HISTORIC LANDMARK COMMISSION STAFF REPORT

Planning and Zoning
Division
Community & Economic
Development Department

Burt Residential Redevelopment New Construction Petition 470-08-06 Generally located at 754 North 300 West Street in the Capitol Hill Historic District May 7, 2008

A100

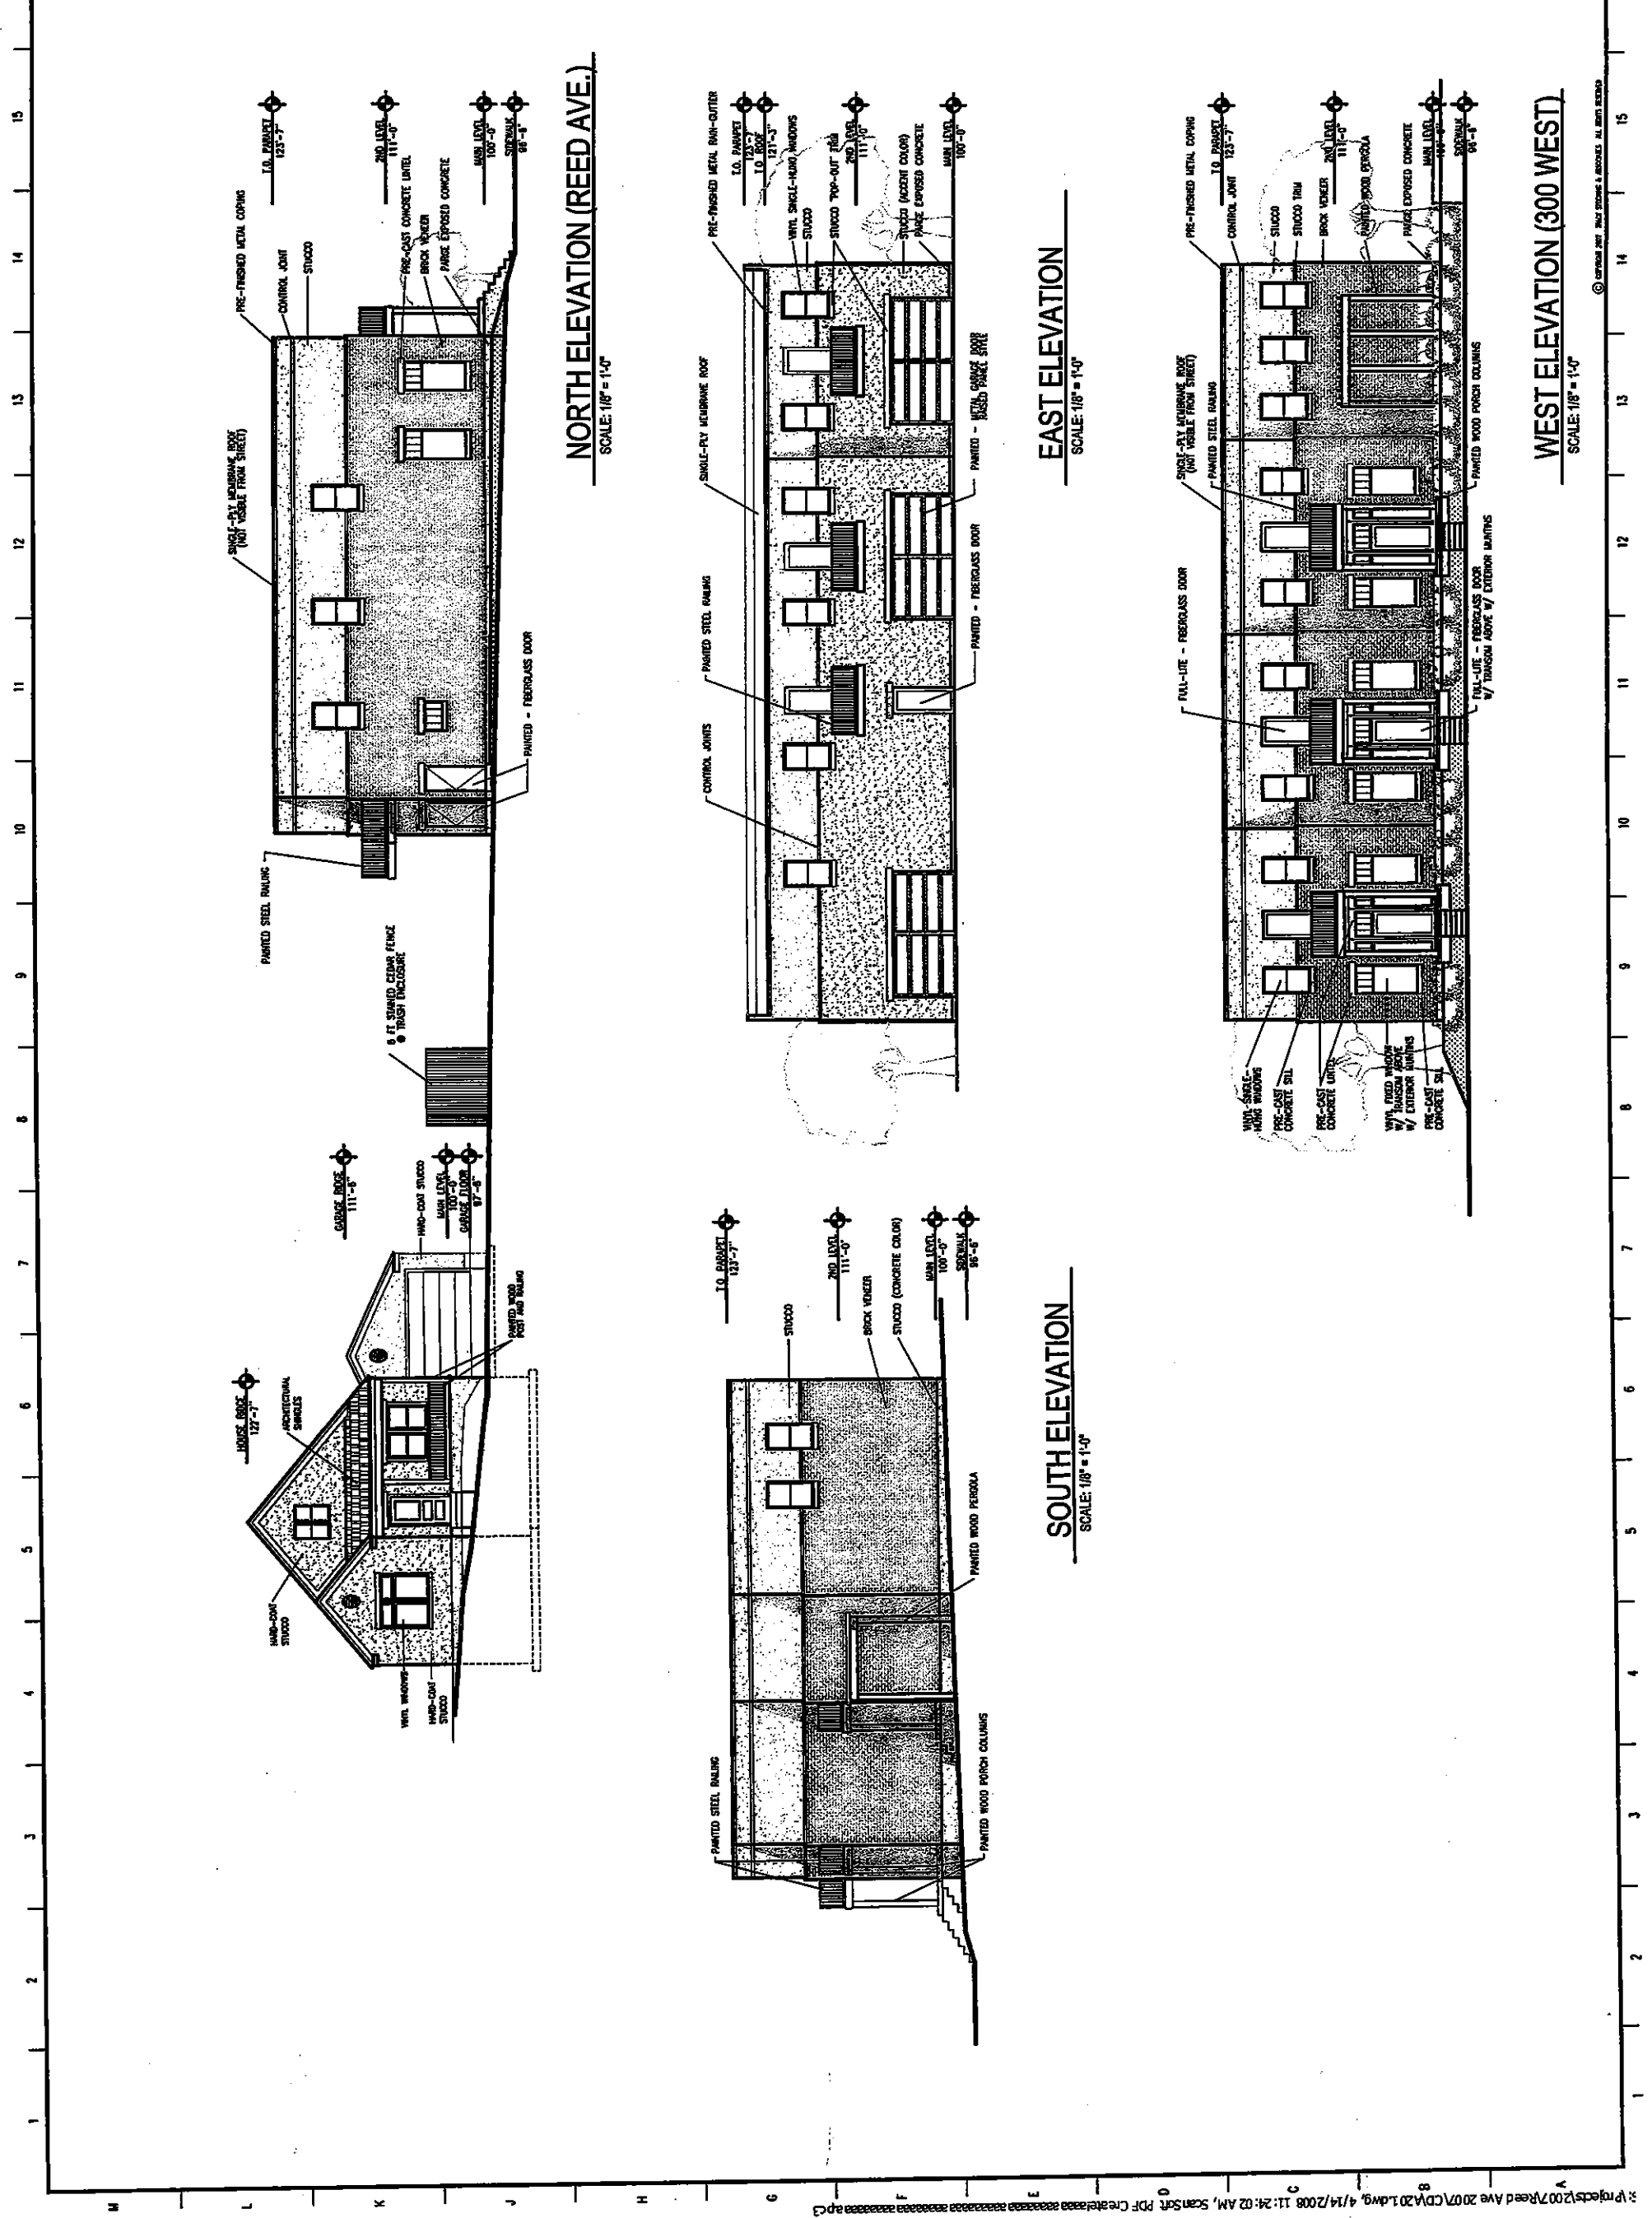
The proposed site plan was discussed with the City’s Development Review Team (DRT) and their comments are attached to this staff report as Attachment C. All proposed work must comply with height, yard and bulk requirements of the SR-1A and MU zoning districts and the Accessory Uses, Buildings and Structures chapter of the Ordinance. The ordinance requirements include the following:

Finding: The site and building designs comply with the code requirements of the Zoning Ordinance which will be verified prior to building permit issuance.

Finding: The final site and building designs comply with the code requirements of the Zoning Ordinance which will be verified prior to building permit issuance.

- **Accessory structures in a required yard:** Accessory structures shall be located a maximum of five feet from the rear property line. The drawings indicate an eighteen inch (18") setback from the rear property line.

- **Yard coverage:** Any portion of an accessory structure shall not occupy more than 50% of the area located between the rear façade of the principle building and the rear lot line. The drawings indicate a surface coverage of 42% of the rear yard.

- **Building coverage:** The maximum coverage of all accessory buildings shall not exceed 40% of the building footprint of the principal structure. The drawings indicate a building footprint coverage of approximately 35% of the principal building footprint.

- **Maximum building height for pitched roofs:** The height is fourteen feet (14') measured to the peak of the roof. The proposed height of the detached garage is consistent with this requirement since the pitch of the roof (5:12) is shallow to meet the maximum building height requirement.

Finding: The proposed accessory structure complies with the general yard, bulk and height limitations of the Ordinance which will be verified prior to building permit issuance.
